**ZONING BOARD OF APPEALS SPECIAL MEETING**  
**LOCATION: TOWNSHIP ANNEX, 7527 HIGHLAND ROAD, WHITE LAKE, MICHIGAN 48383**  
**THURSDAY, MAY 25, 2023 – 5:00 PM**

**TO:** Zoning Board of Appeals  
**FROM:** Justin Quagliata, Staff Planner  
**DATE:** May 25, 2023

SCALE:	AS SHOWN
SHEET NO:	L5.01
KE 2022.226

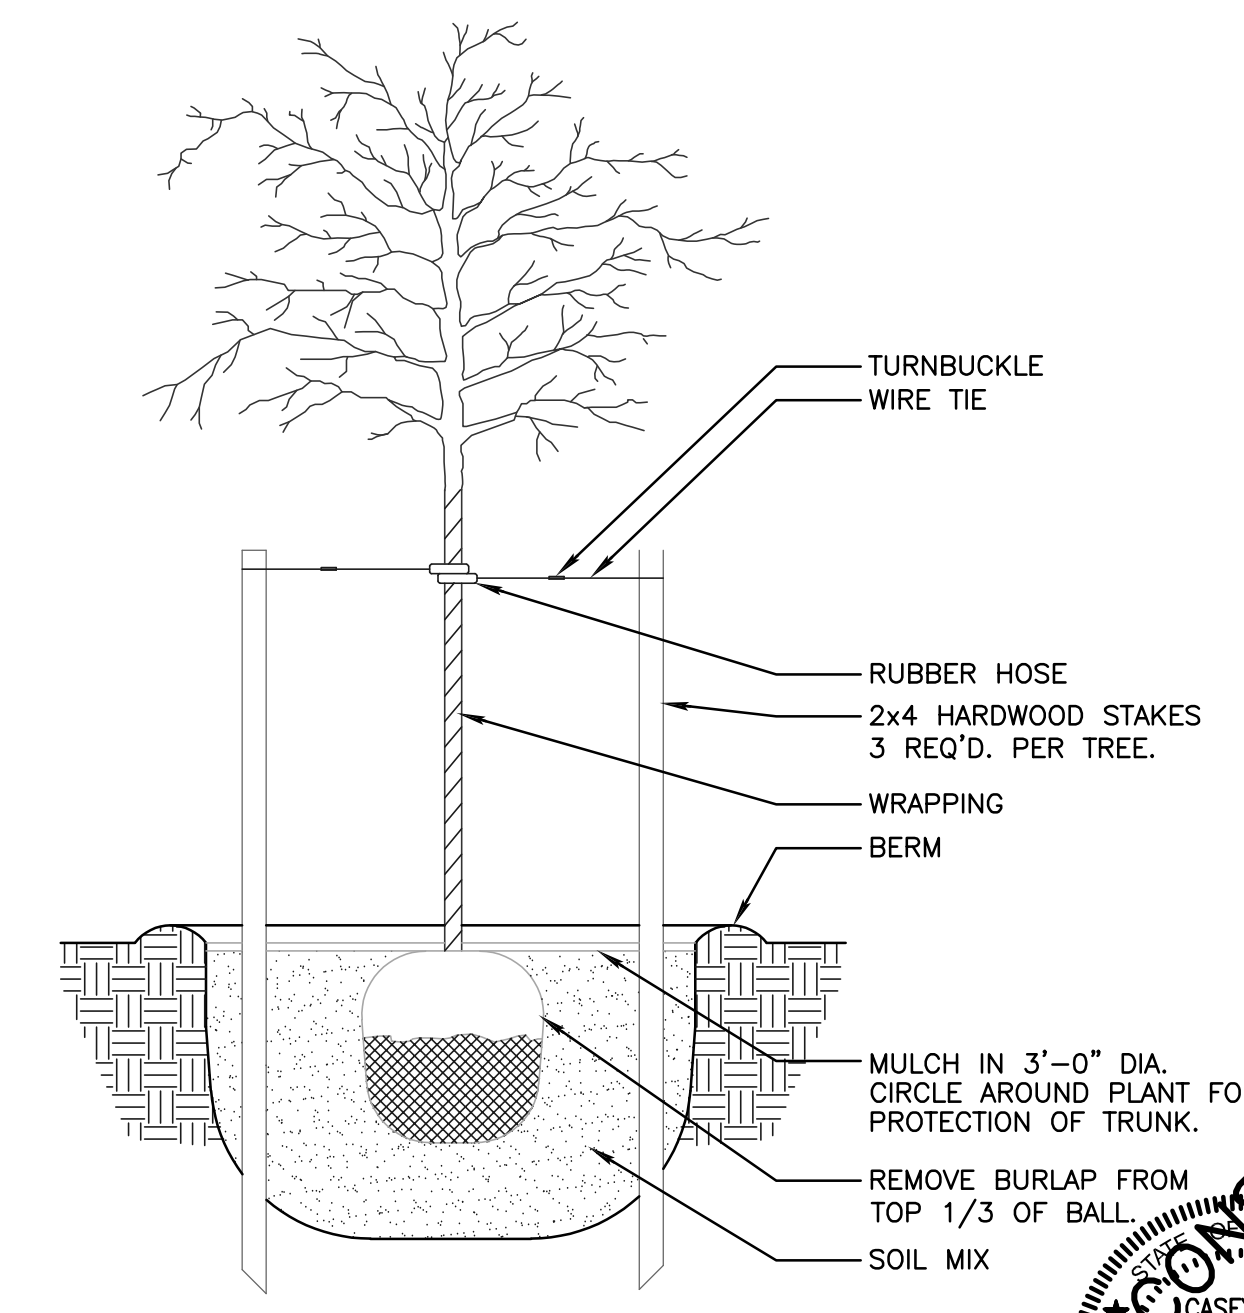
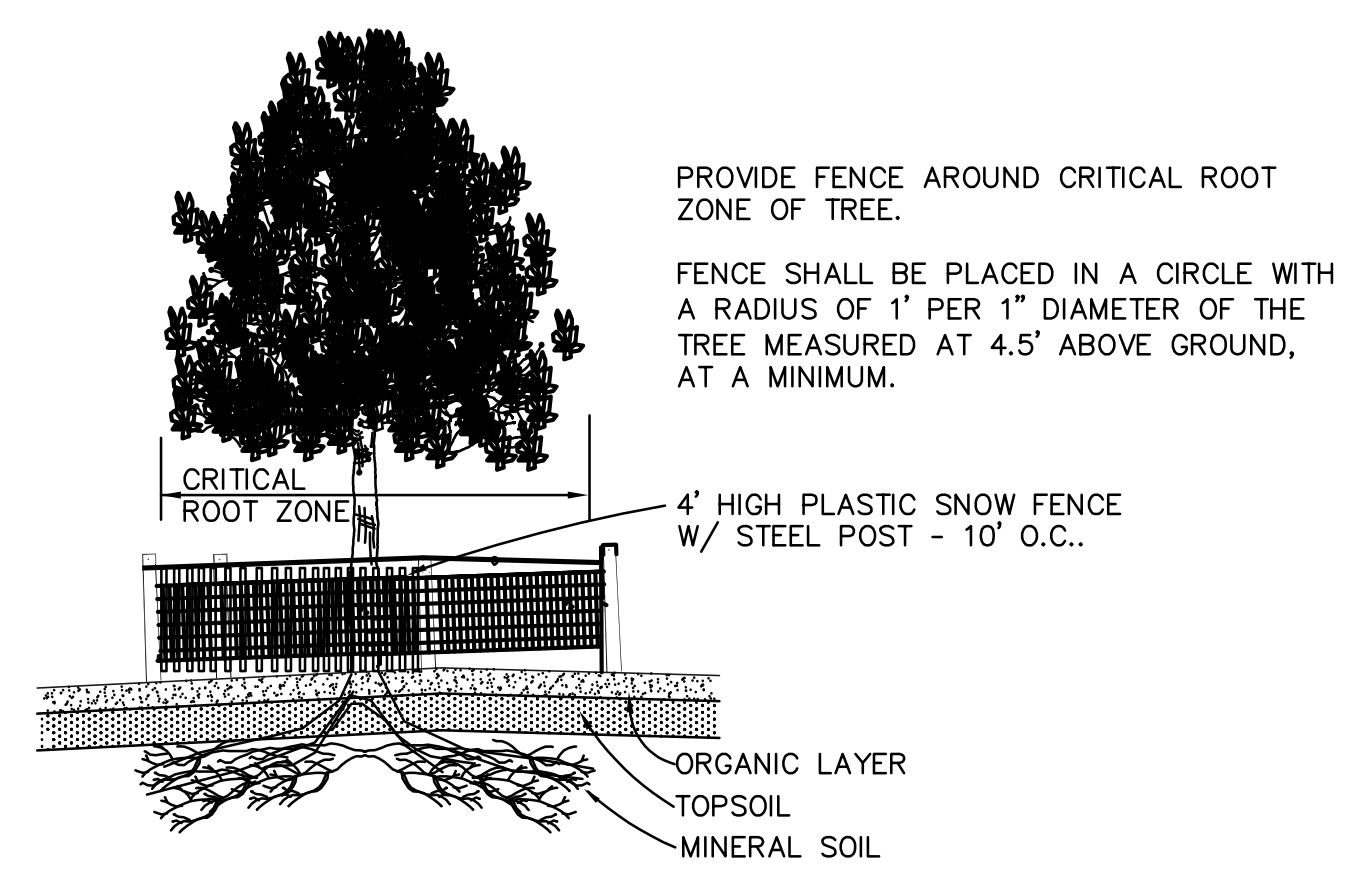
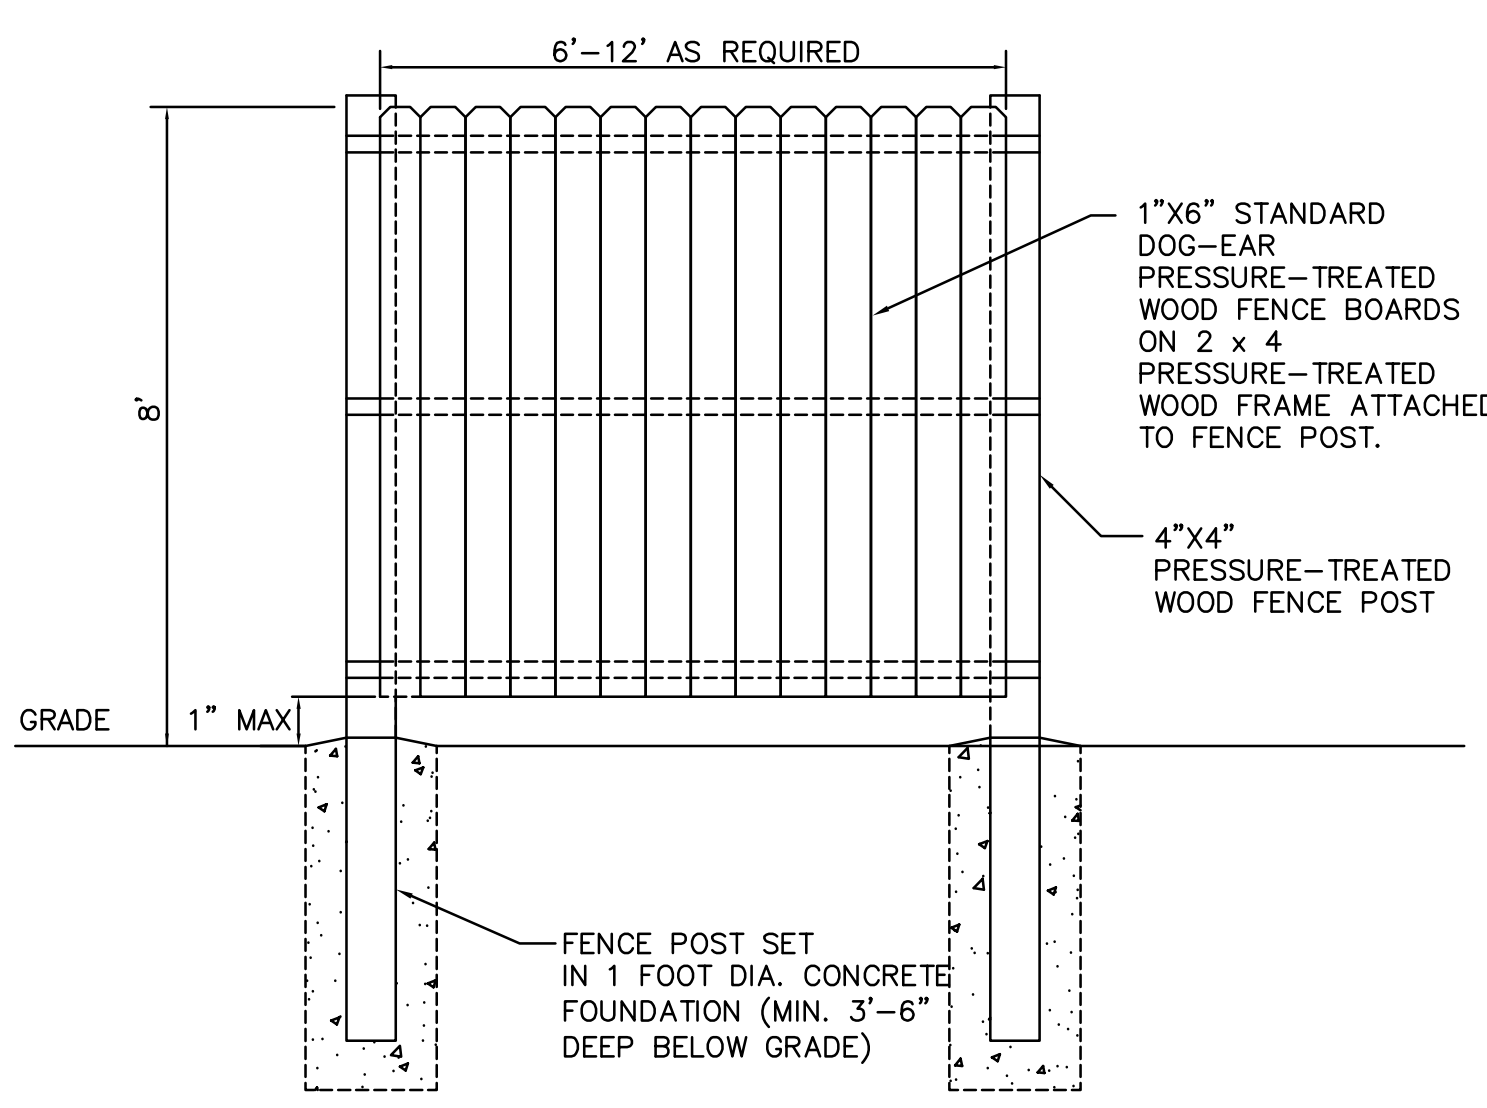
- Note 15 and the tree and shrub planting details on Sheet C5.01 mention mulch. Per the Zoning Ordinance, the mulch product itself shall be at least double-shredded quality. Revise accordingly. **(Comment outstanding. Contrary to the Applicant's response letter to the first review, the notes on Sheet L5.01 have not been revised).**

- The sheet number on the landscape details sheet is intended to be labeled L5.01 but is labeled C5.01. Revise accordingly. **(Comment addressed. The sheet number has been corrected on the revised plans).**

- Tree stakes, guy wires, and tree wrap shall be removed after 1 year. Add note to landscape plan. **(Comment addressed. A note has been added to the landscape specifications on Sheet L5.01).**
